# **SERVICE BULLETIN**

**DATE**: 30<sup>th</sup> April, 2012

# MACHINE OR VEHICLE AFFECTED: ABC 3-Drum Trailers

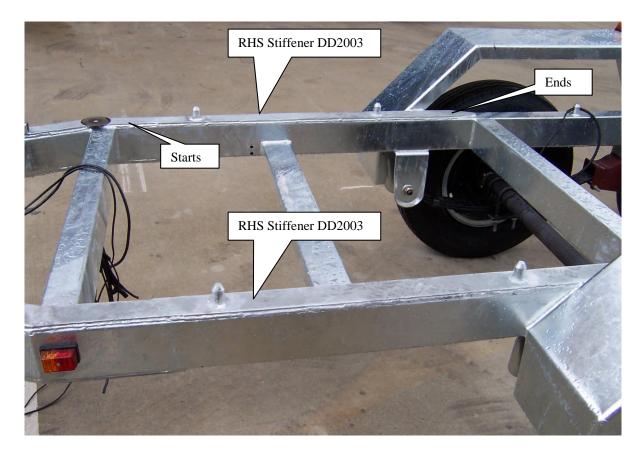
Machine owners must immediately implement an inspection to confirm if RHS Stiffener DD2003 is fitted for the trailer serial numbers above. If this is not fitted, please contact Redmond Gary to arrange rework.

Note: Some trailers have fixed drum frames and others have removable drum frames as illustrated here. In both cases this stiffener is required.

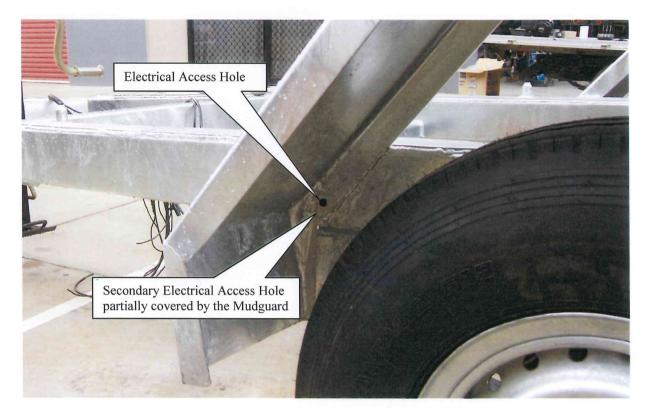
Machine owners must immediately implement an inspection of the Front Suspension hanger welding and the electrical access hole directly under the front of the mudguards. If there is any sign of cracking, the trailer is to be withdrawn from service until repair and the additional RHS stiffeners added.

Additionally an inspection is needed to confirm that there is not a second electrical access hole directly under the front of the mudguards. If a second electrical hole is found then this trailer should be withdrawn from service until an additional RHS stiffener is added.
